## **R1 North 1st Floor – Replace Hensel Phelps West Auditorium & East Classroom Lighting & Lighting Controls**

**Project Number: 22-122843**

**Friday April 1, 2022  
ADDENDUM 1**

**E2.1**

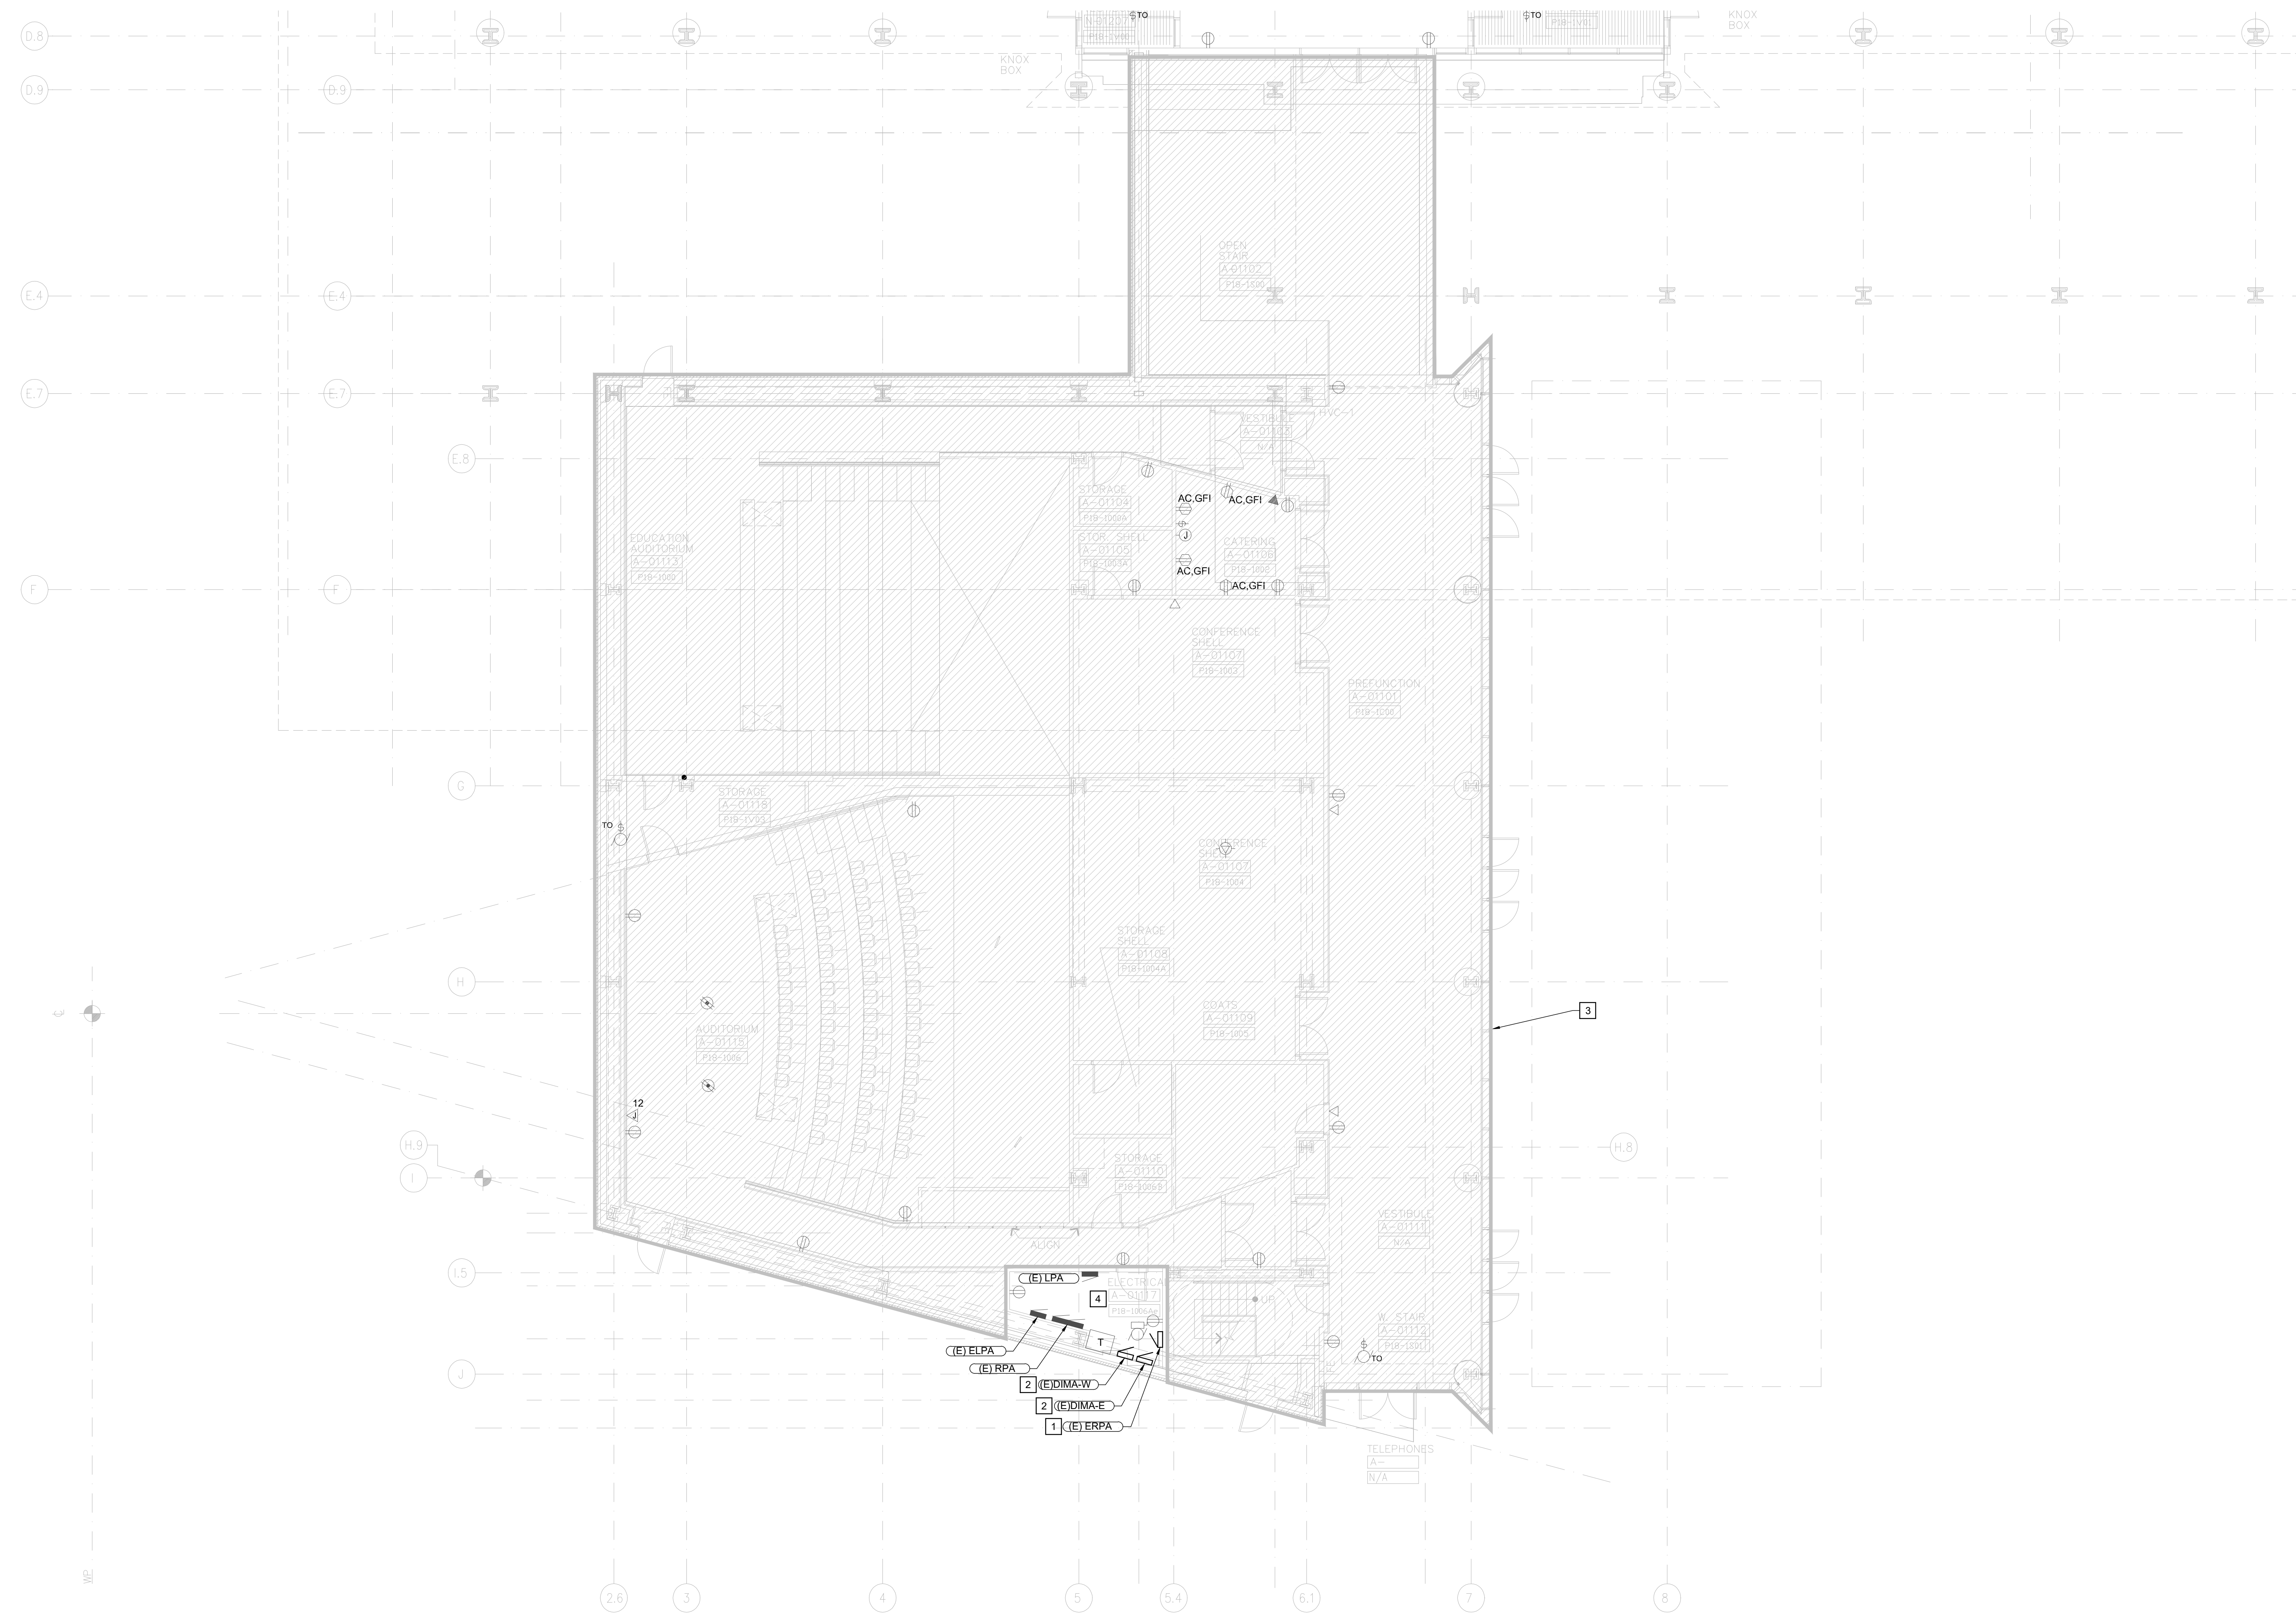
- 1. Who will provide data drops to the new lighting control panels?**

- EXISTING DIMMING PANEL TO BE REPLACED WITH BREAKER PANEL. REFER TO SHEET E0.2.
- EXISTING DIMMING PANEL TO BE REPLACED WITH NEW DIMMING PANELS, REFER TO LIGHTING CONTROL RISER.
- HATCHED AREA IS NOT IN SCOPE OF WORK.
- PROVIDE 2 ETHERNET DATA JACKS FOR THE ARP PANELS. PROVIDE (1) 1-1/2" CONDUIT, WITH PULL STRING, FROM EXISTING PATCH PANEL IN THE ROOM TO THE FINAL LIGHTING CONTROL PANEL LOCATION. CONDUIT SHALL TERMINATE IN A 4X4 BOX WITH SINGLE GANG TRIM RING. COORDINATE EXACT REQUIREMENTS WITH OWNER.

**Response: The CU Anschutz Office of Information Technology (OIT) group will provide and install cabling, data jacks and device plate. Electrical contractor to provide raceway as indicated on attached Addendum #1 drawings.**
